From: [REDACTED]
To: [SizewellC](#)
Subject: Fwd: Response to BEIS request Ref: EN010012 18th March
Date: 21 March 2022 06:51:08
Attachments: [Response to BEIS Enquiry Ref EN010012 18th March 2022.pdf](#)
[SzC Main nuclear platform flood resilience in the next century.pdf](#)

RE: Response to your ref: EN010012 18th March 2022

Sizewell C Main nuclear platform flood resilience in the next century.

Figure 14: The Beast from the East storm, 2099 Sea Level – Post-storm bed elevation for the SCDF with present-day shoreline (left) and SCDF-future shoreline position (right) cases. (BEEMS Technical Report TR545 Version 2.0).

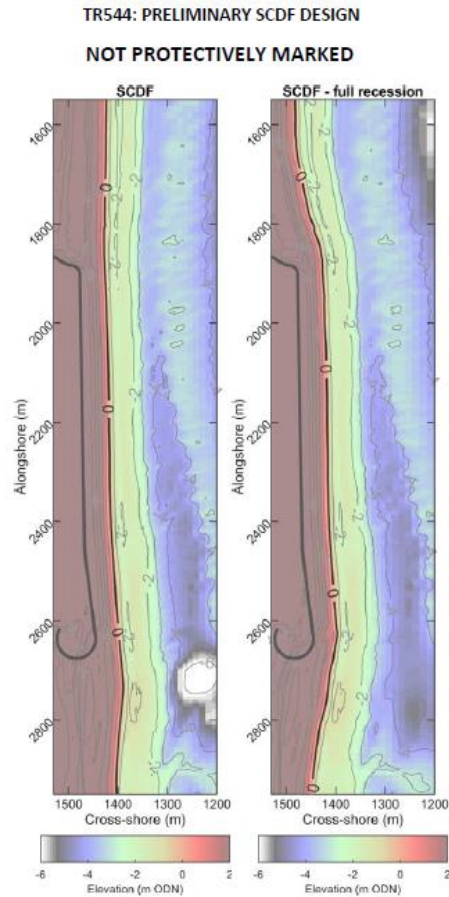
The 'severely receded shoreline' claimed by TR544 is shown following (Page 49 TR544 REP10-124) and reproduced below:

In my view, this shoreline cannot be regarded as 'severely receded' and hence cannot be regarded as 'conservative modelling'.
